OCTOBER 9, 2025

BOARD OF COMMISSIONERS REGULAR PUBLIC MEETING

**RE: Executive Summary for LD-25-01 – 1526 Fairview Avenue
PARID: 30-00-18860-00-1/ TMID: 30196 017
Preliminary/Final Major Subdivision & Land Development Plans Review (2nd Submission)**

RE: LD-25-01 – 1526 Fairview Avenue
PARID: 30-00-18860-00-1/ TMID: 30196 017
Preliminary/Final Major Subdivision & Land Development Plans Review (2nd Submission)

RECORD PLAN (SHEET 1 OF 1 TO BE RECORDED)

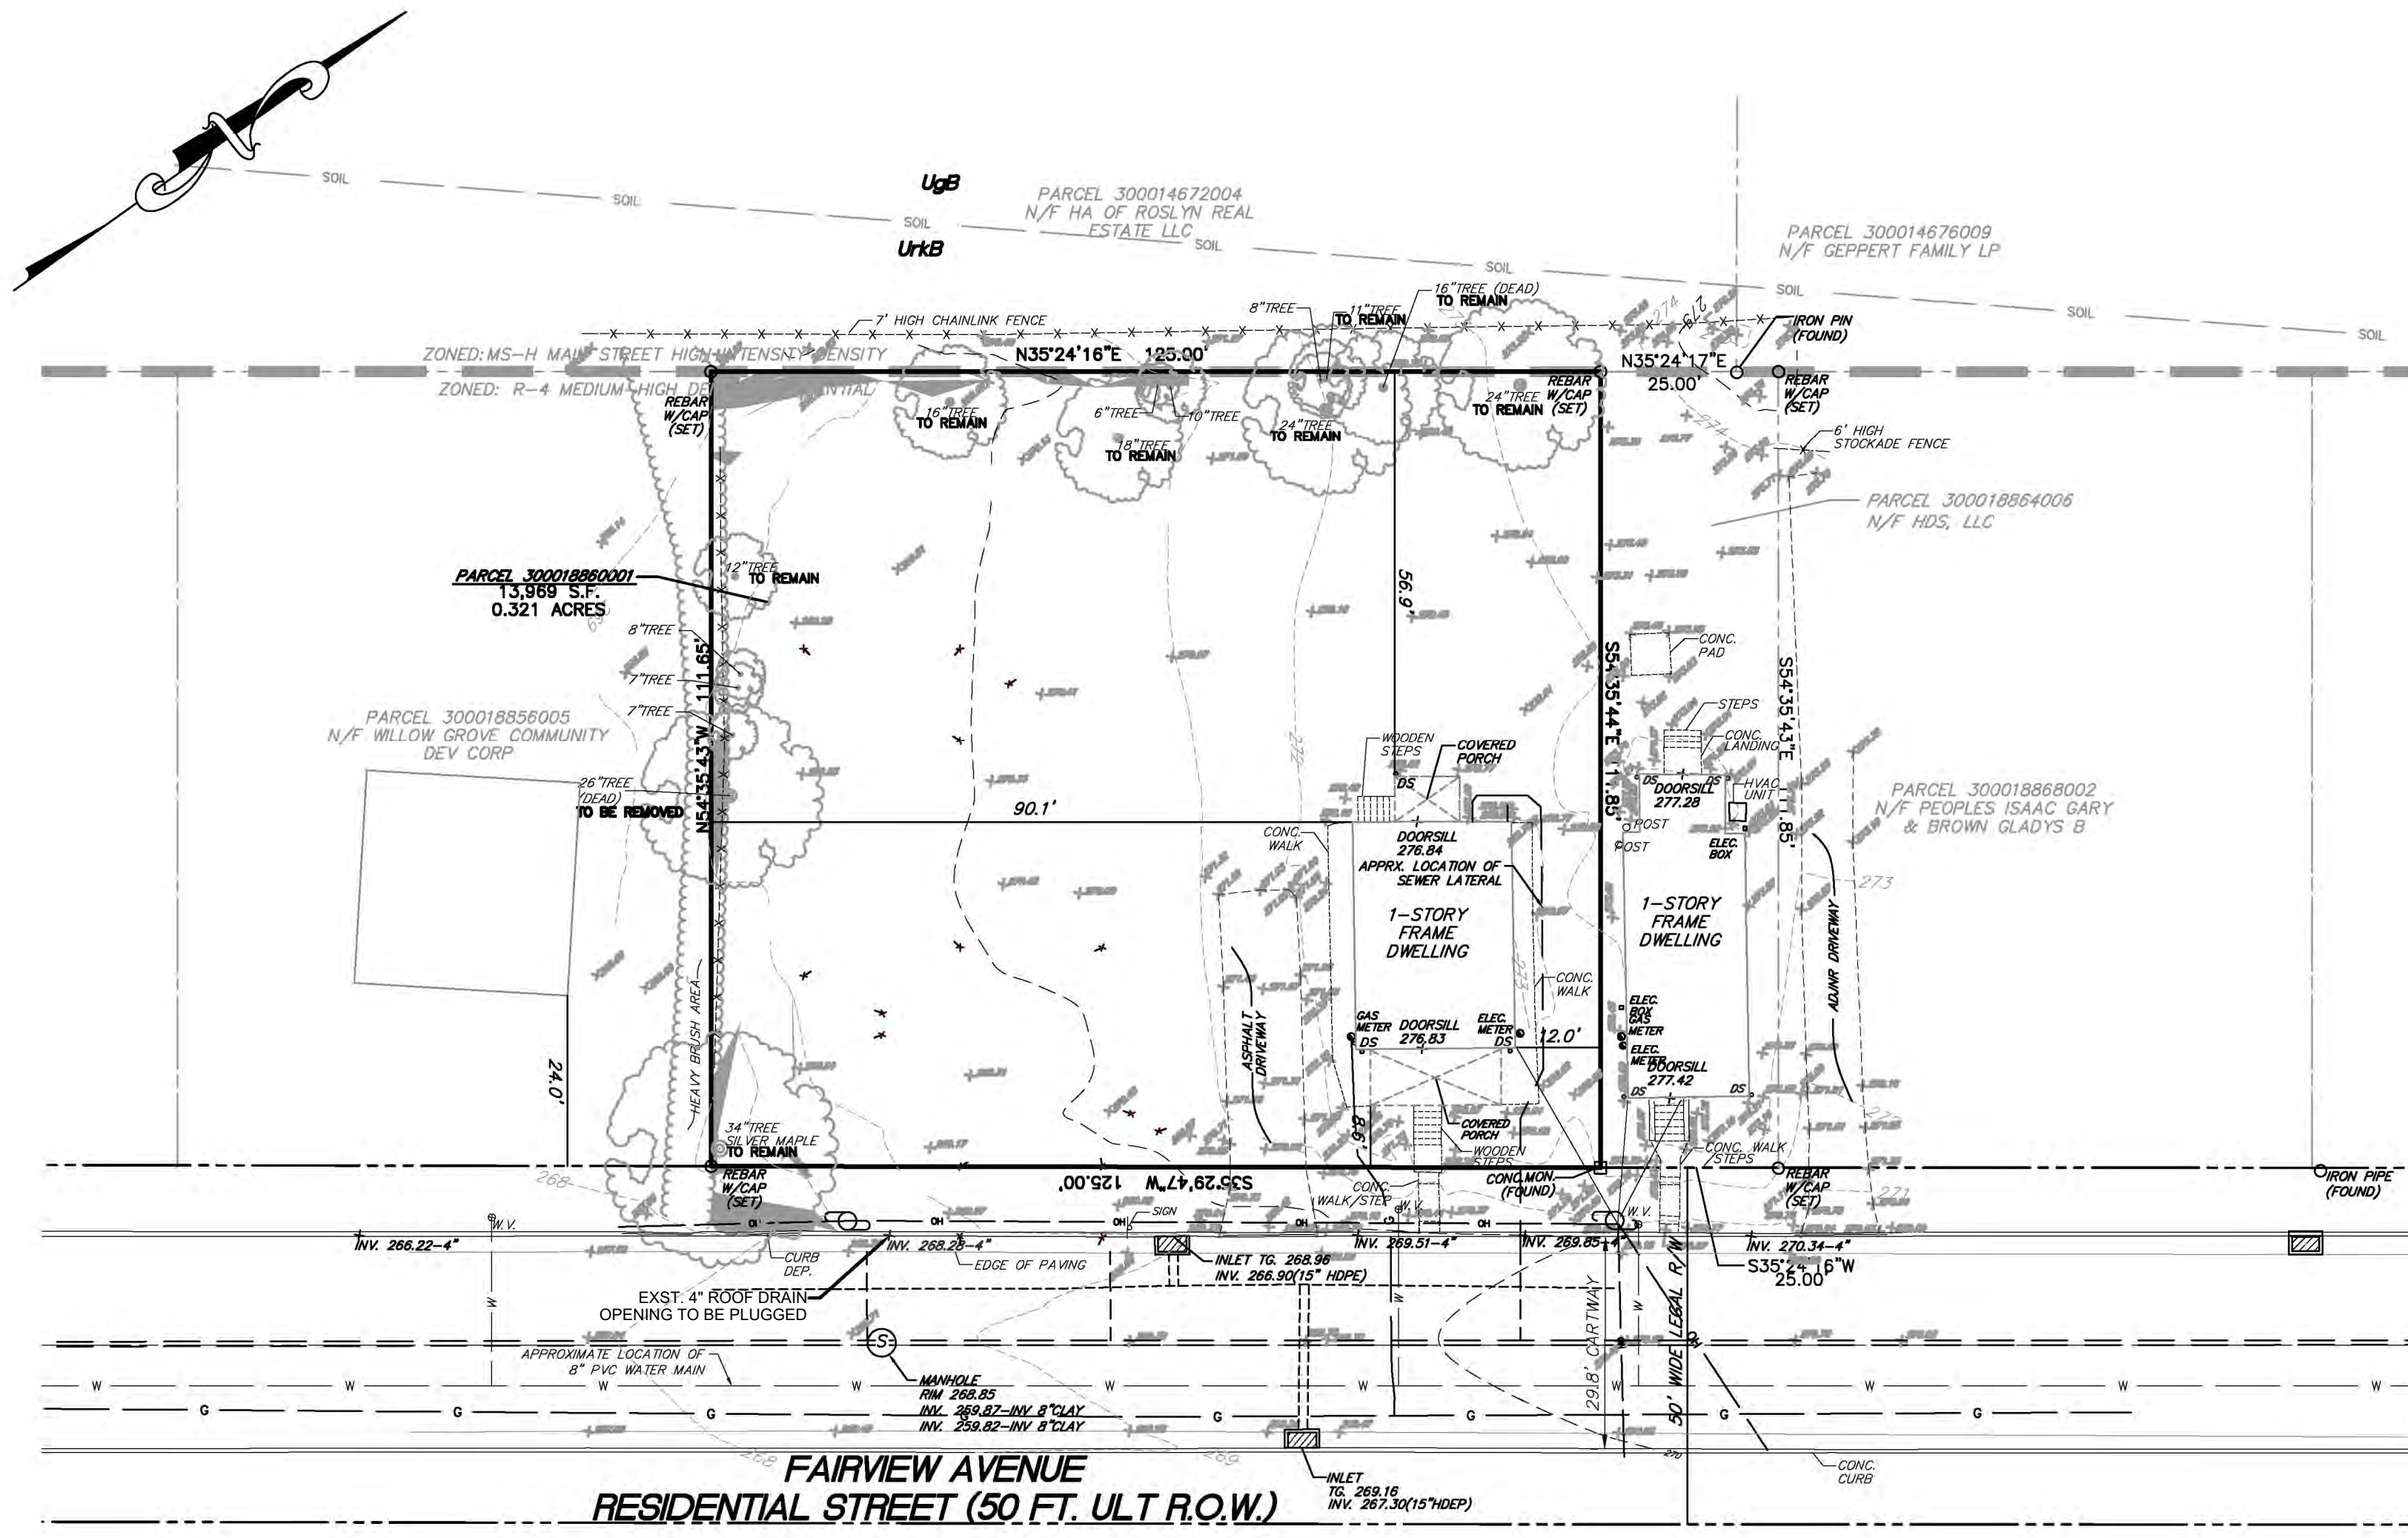
The condition of approval for the above variances shall be included on the Record Plan (Sheet 1).

Provide additional room for the seal of the Township Engineer to ensure no text overrides with the secretary's signature line above in the "Board of Commissioners Approval" signature block on the Record Plan (Sheet 1).

4. Plan sheets to be recorded shall be indicated on the Record Plan (Sheet 1). Plans to be recorded shall include Sheets 1, 3, 4, and 8.

The condition of approval for the above variances shall be included on the Record Plan (Sheet 1).

This waiver request shall be revised on the waiver request letter and the Record Plan (Sheet 1) to indicate the correct Code Section of §146-33.G instead of “§146-33(7)” which does not exist in the current SALDO code.

This waiver request shall be revised on the waiver request letter and the Record Plan (Sheet 1) to indicate the correct Code Section of §146-35.C.(1) instead of “§146-35(3)(A)” which does not exist in the current SALDO code.

52. The Index of Sheets on the Record Plan (Sheet 1) shall indicate which plans are to be recorded.
53. The narrow longitudinal zoning district abutting the R4 zoning district located to the east of the site on the Location Map is mislabeled as "MS-H" and should be corrected to the "MS-L" zoning district. Similarly, the "MS-H" label for the horizontal area between Arnold Avenue and Fairhill Avenue should also be corrected to the "MS-L" zoning district.

3 of 8

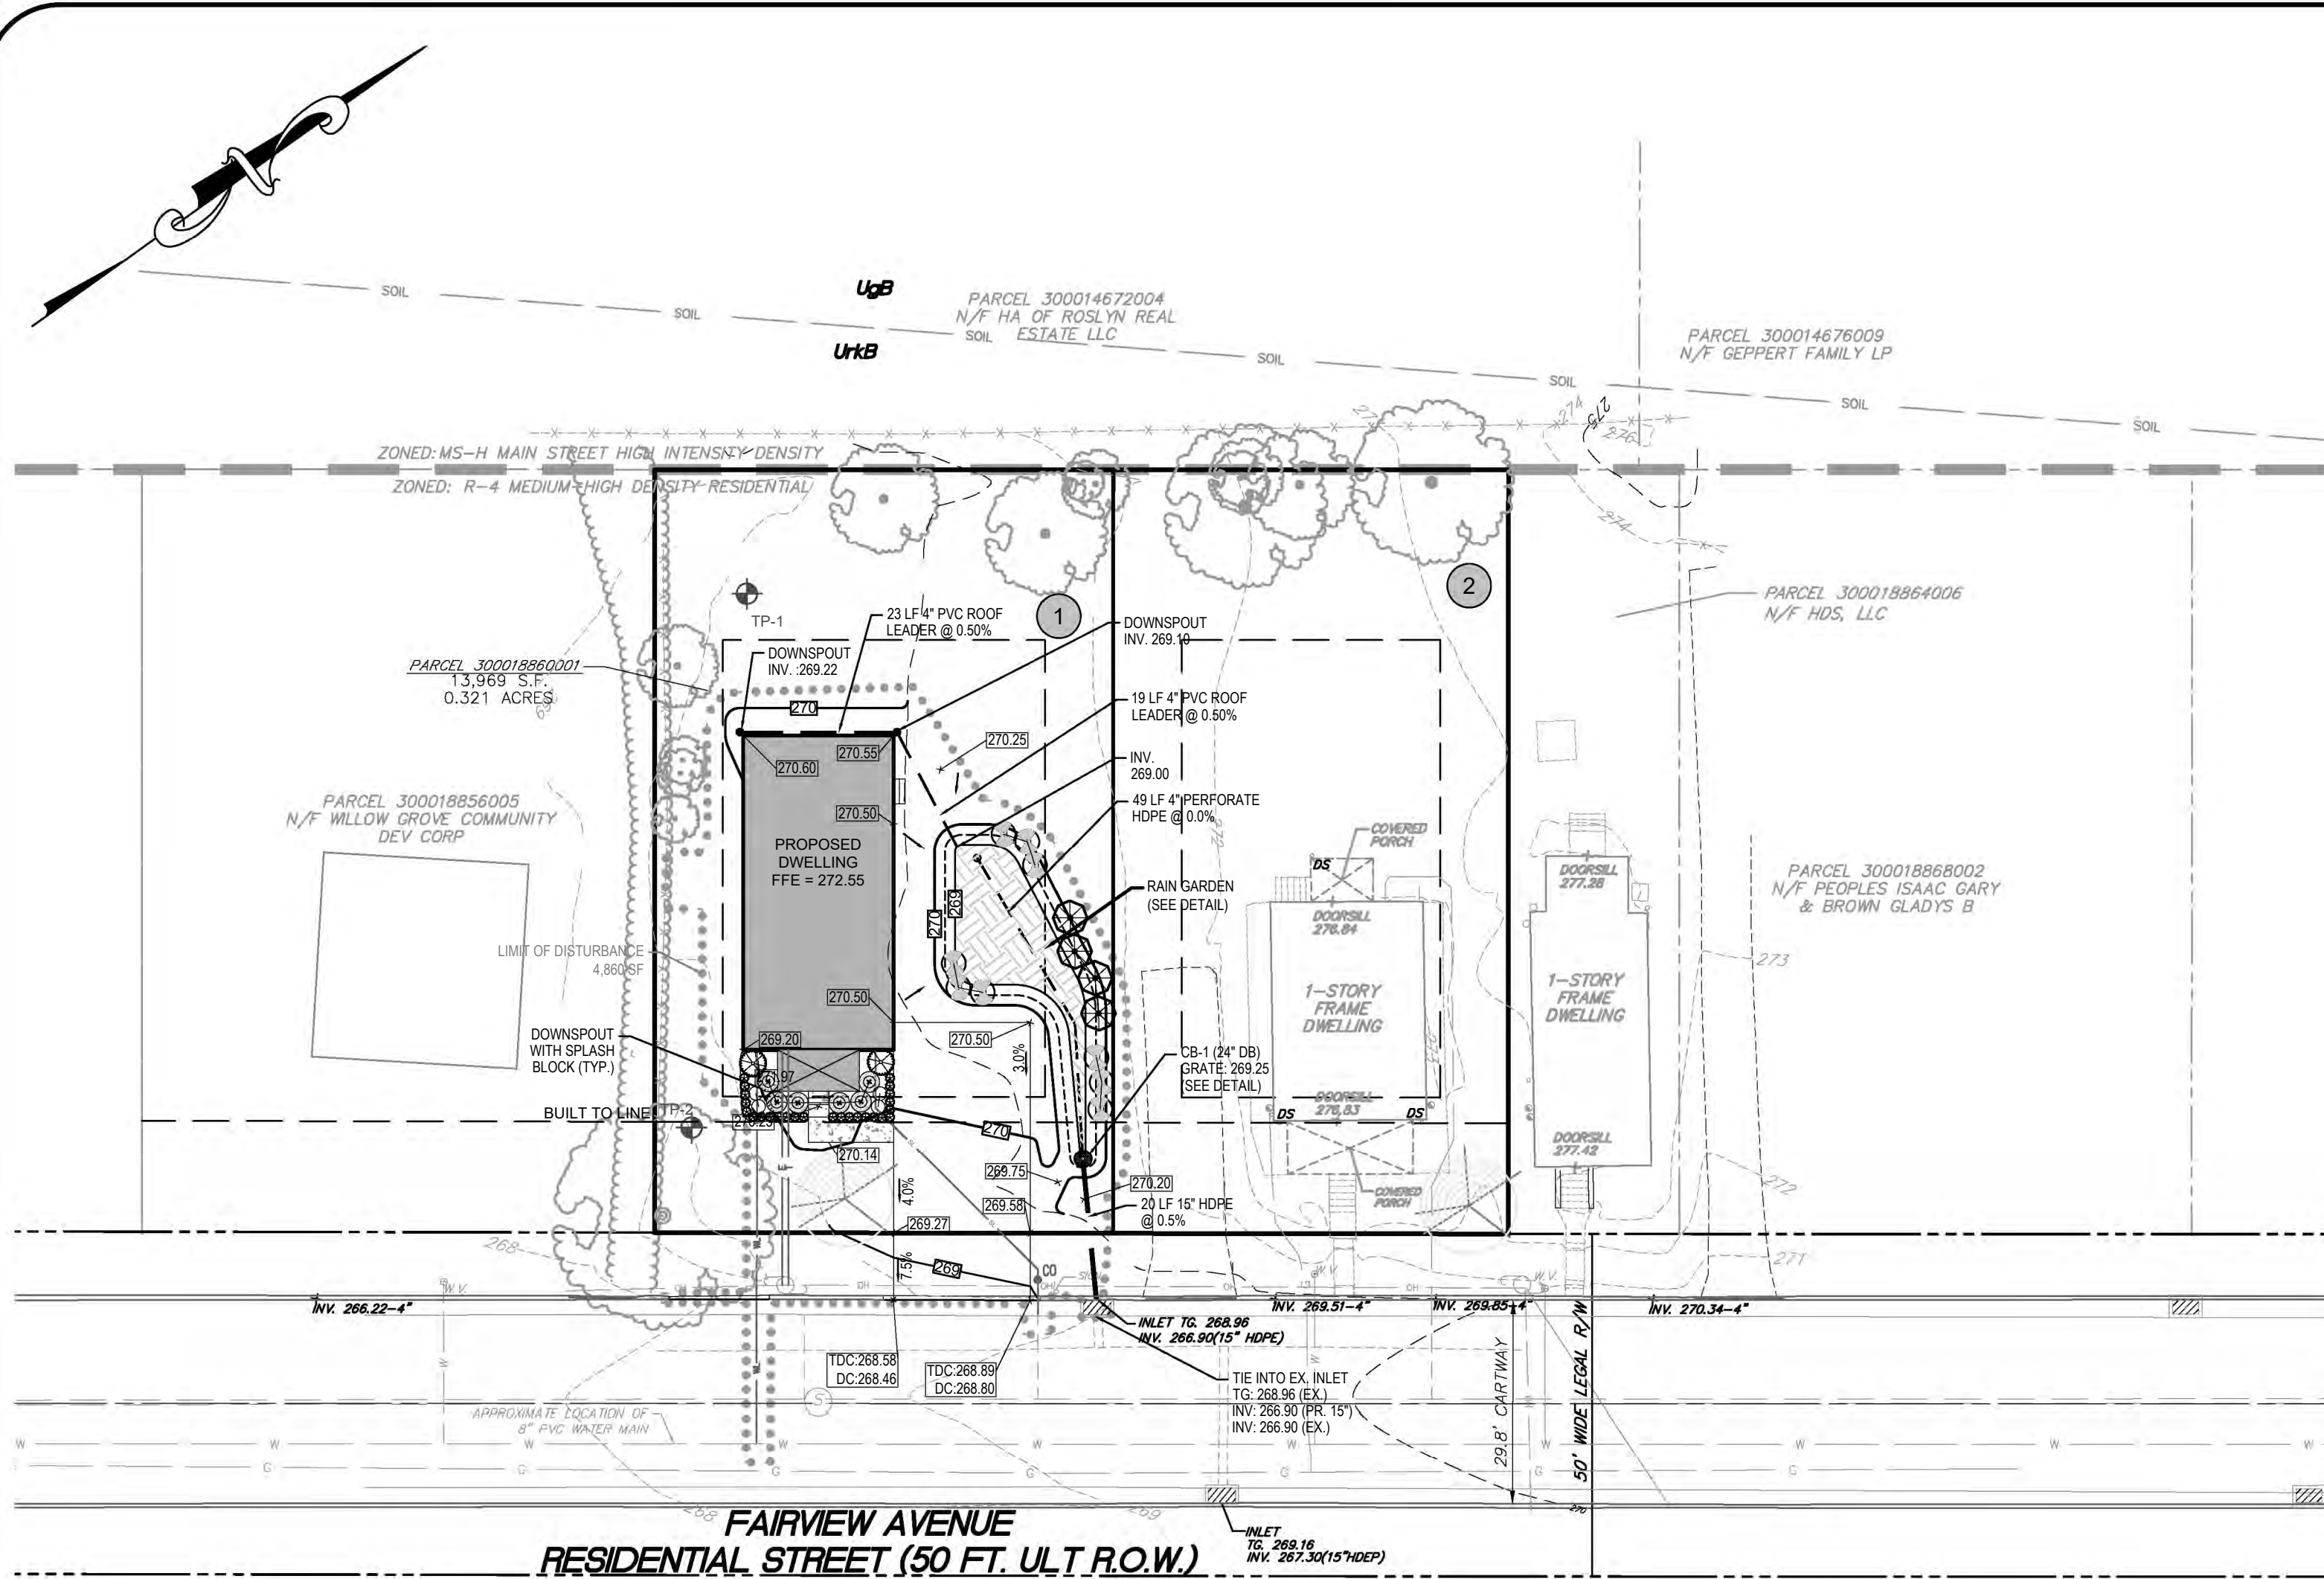
A limit of disturbance area shall be delineated and called out on the Grading and Utilities Plan (Sheet 3).

The above note shall be provided on the Grading and Utility Plan (Sheet 3).
